# Access Compliance Report

## Public Rights-of-Way

### (Curb Ramps)

Intersection ID: 10041619	Main Street: WHITEHALL COMMONS CENTER DR	Cross Street: N/A	Location: NW
ADA ID: 587A65618BE5	Ramp Type: PerpDiag	Initial Pass/Fail: Fail	Overall Compliance: No
Severity Score: 8.75			
Codes/Mitigation Info/Possible Solution		Field Measurements/Component Compliance

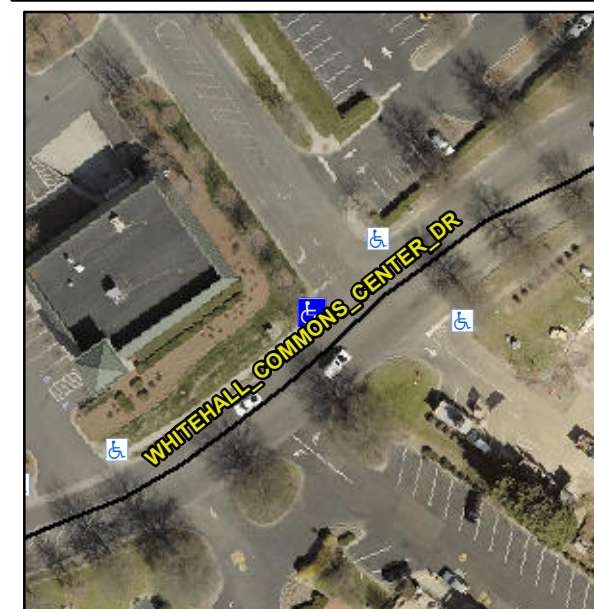
**Not Found, R304.5.1**

Compliance	Description	Data	Compliance	Description	Data
N/A	Ramp Length (in)	39.0	Yes	Ramp Slope (%)	5.7
No	Ramp Width (in)	42.5	Yes	Ramp XSlope (%)	0.7
N/A	Flare Type LT	N/A	N/A	Flare Type RT	N/A
N/A	Flare Slope LT (%)	N/A	N/A	Flare Slope RT (%)	N/A
N/A	Flare Traversable LT?	N/A	N/A	Flare Traversable RT?	N/A
N/A	Landing Length (in)	N/A	N/A	DWS Provided?	N/A
N/A	Landing Width (in)	N/A	N/A	DWS Contrast?	N/A
N/A	Landing Slope (%)	N/A	N/A	DWS Length (in)	N/A
N/A	Landing X Slope (%)	N/A	N/A	DWS Full Width?	N/A
N/A	Landing Curb? (Y/N)	N/A	N/A	DWS Offset (in)	N/A
N/A	Shared Landing?	N/A			
N/A	Gutter Ponding?	N/A	N/A	Gutter Slope (%)	N/A
N/A	Gutter Lip Ht (in)	N/A	N/A	Gutter X Slope (%)	N/A
N/A	Painted X Walk1?	No	N/A	Painted X Walk2?	No
	X Walk 1 Direction	To SE		X Walk 2 Direction	To NE
N/A	X Walk 1 Width (in)	N/A	N/A	X Walk 2 Width (in)	N/A
	X Walk 1 Slope (%)	2.1		X Walk 2 Slope (%)	1.5
	X Walk 1 X Slope (%)	1.2		X Walk 2 X Slope (%)	1.3

**Remove & Replace Curb Ramp With Two New Directional Ramps or Equivalent.**
